**CONSULTATION ON HANDOVER OF TAIL LOCAL  
LEASED CIRCUITS UNDER SCHEDULE 7B OF  
SINGAPORE TELECOMMUNICATIONS LIMITED'S  
REFERENCE INTERCONNECTION OFFER**

**25 July 2005**

**JOINT SUBMISSION OF MEMBERS OF  
THE ASIA PACIFIC CARRIERS'  
COALITION**

**V.35 SingTel LX Interconnection - the Interface Equipment Requirements**

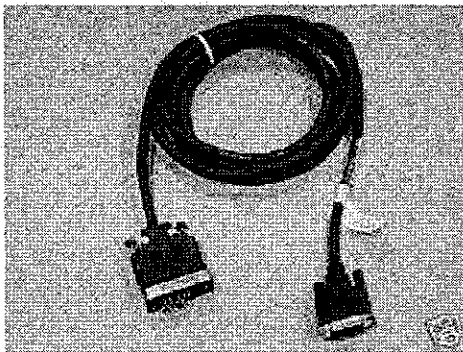
Each set of connecting cable, consisting of a Winchester Interface equipment and a dedicated V.35 Serial cable, is required to meet the interconnection needs for every individual customer.

In other words, a carrier seeking to serve 300 customers in the vicinity of a SingTel local exchange would require 300 dedicated sets of the equipment pictured above to be installed at the local exchange. The V.35 Winchester interface equipment needs to be housed in collocation racks. The V.35 and its auxiliary equipment (for example, power amp fuses) could result in considerable collocation requirements. This results in considerable demands on space in each of the SingTel local exchanges in which the competitive carrier plans to collocate for Local Leased lines. Investing in customer premise type connection equipment to meet the demands of a carrier to carrier interconnection is also highly inefficient from an engineering and commercial perspective.

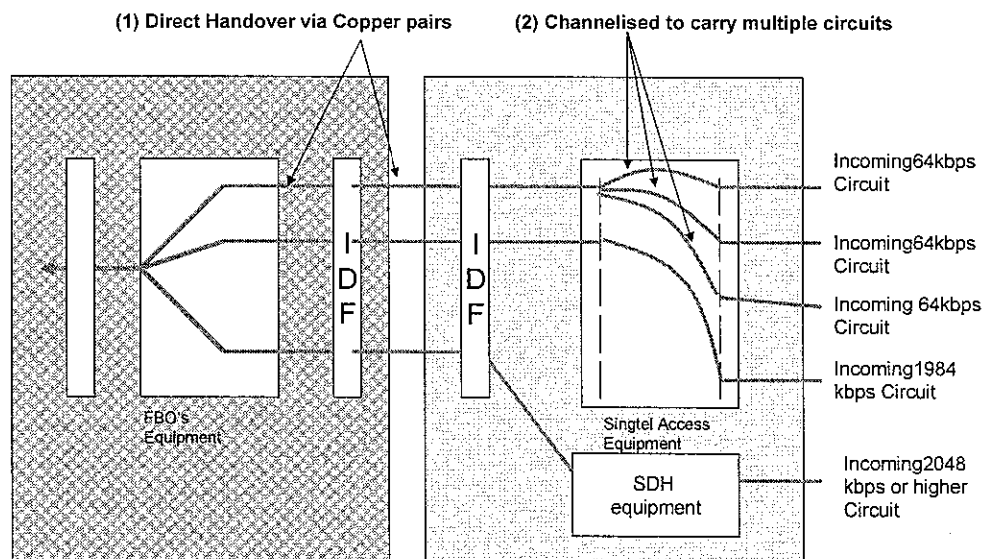
The cumbersome interconnection arrangement under an un-multiplexed V.35 interface can be remedied in-part with the designation of a multiplexed G.703 interface at SingTel's local exchanges for the regulated local leased lines. A multiplexed G.703 interface would take away the requirement for the Winchester type connections and the heavy demands on collocation racks. This would also replace the multiple equipment and space requirements with a requirement for a single collocation rack to meet the needs of hundreds of customer connections.

Whilst APCC supports the IDA's proposals for a Direct Handover Configuration, APCC believes that the IDA should require SingTel to handover circuits as channelised circuits. The changes proposed by the IDA, from the existing handover configuration to the IDA's proposed approach is effectively a change in the mechanism for handover but, in both cases, the licensed operator remains responsible for the grooming of the circuits which it receives. APCC submits that, in practice, the most efficient mechanism for the provision of tail LLCs is for SingTel to handover channelised circuits. This is the delivery mechanism which competitive carriers would like to take wholesale LLCs and we submit that this service should form a wholesale service available under the RIO. In the vast majority of international jurisdictions, including Australia and the UK, incumbent operators provide LLCs on a channelised circuit basis. The APCC's preferred approach is illustrated in the self-explanatory diagram below.

APCC submits that the IDA's proposed Direct Handover Configuration **together** with channelization capability for tail LLCs will achieve the optimal solution.
